Moray Offshore Renewables Limited application for Marine Licenses & Section 36 Consent

Moray Offshore Renewables Limited application for Marine Licenses & Section 36 Consent – Additional Information

Moray Offshore Renewables Limited and Beatrice Offshore Wind Limited applications for Marine Licenses & Section 36 Consent – RSPB Scotland consultation response

ANNEX: DETAILED RSPB SCOTLAND COMMENTS – DECEMBER 2013

Figure 1. Kittiwake tracking data (RSPB confidential unpublished data)

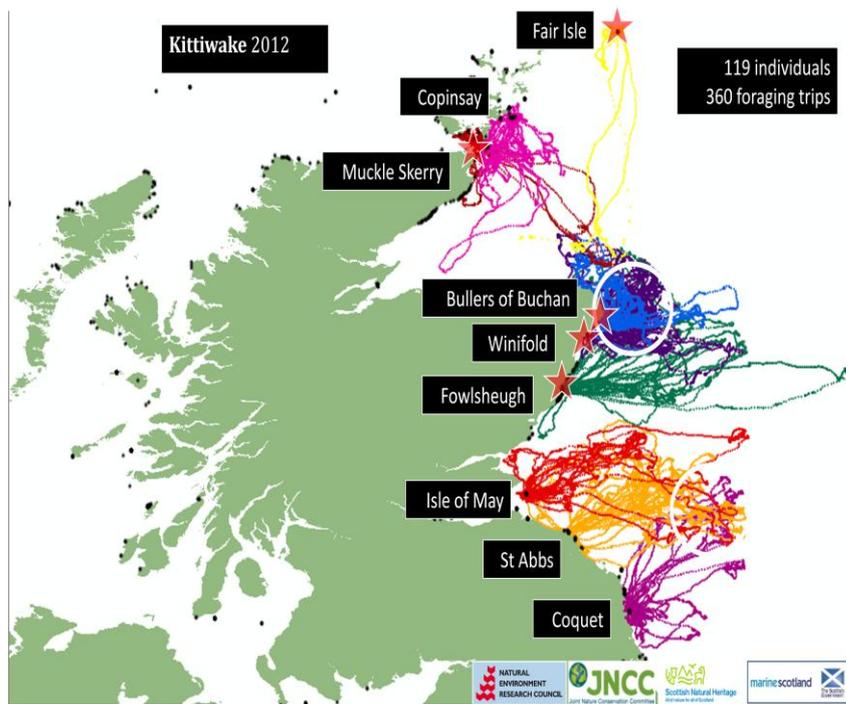
With regard to Kittiwake, (Figure 1), there is a possibility that kittiwakes from Fair Isle, and perhaps mainland cliff colonies south of Moray, might use the area including the proposed offshore wind farm sites. Although none of our records coincide exactly with the windfarm sites, one Fair Isle record comes relatively close. These tracking data cannot be used to prove a negative, ie that birds do not use certain locations, but they do provide an indication of areas they definitely do use. It is therefore not possible to completely rule out potential effects on colonies other than the East Caithness Cliffs.
